AGL DALTON POWER PROJECT PREFERRED PROJECT REPORT

4 Preferred Project Report

Upon review of the Draft Response to Submissions Report, DP&I made the following comments on additional information required about Traffic and Transport arrangements for the proposal:

Figure 4-17 Proposed route that construction traffic and deliveries will be instructed / directed to utilise during the project

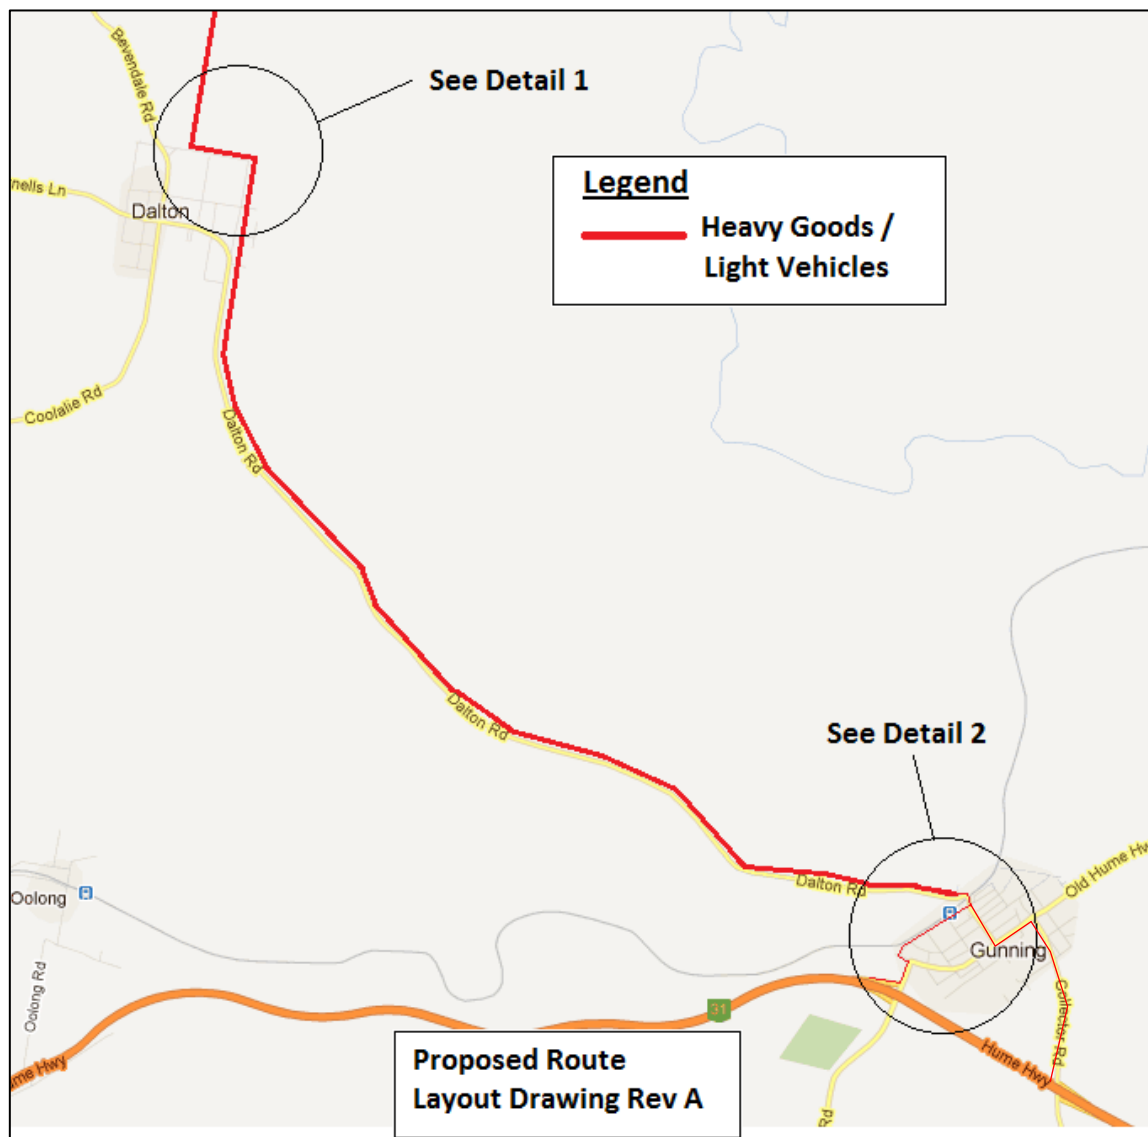
- *Traffic Impacts:*
 - *a map should be provided to detail the proposed route of both the construction traffic and water tankers;*
 - *details of the draft detailed management plan referred to in the response should be elaborated;*
 - *the response states that Walshs Road and Loop Road will be temporarily sealed during construction activities then permanently sealed following construction of each stage ... however it further states that the roads used for access to the site would be sealed at the commencement of construction, and requires clarification; and*
 - *the response' states that the safety and amenity of the community will be managed by experienced haulage contractors in liaison with the RTA and police, however does not elaborate on what these management measures may be (DP&I 2/12/11)*

According to the draft TMP currently the subject of consultation with Council, at this stage, GEL (AGL's preferred contractor) is considering using two access routes to site for both Heavy Vehicles (HV) and Light Vehicles (LV). The route that has been identified is shown below:

Route one from West

- Hume Highway
- Gundaroo Road
- Old Hume Highway
- Grovenor Street
- Warrataw Street

Route two from East

- Hume Highway
- Collector Road
- Gundaroo Street
- Old Hume Highway
- Warrataw Street

And then both routes access site as follows:

- Dalton Road
- Loop Road
- Walshs Roads

GEL has stated that these are to be the most direct and suitable routes to the site and whilst there are issues to be considered when utilising this route, GEL believe these routes to be manageable and safe. The main problem identified with this route is the hazards associated with increased traffic along Grovenor Street, Old Hume Highway through Gunning and Loop Road due to the proximity of local schools and areas known to have children in the nearby area. However, routes will avoid traffic movements along Yass St.
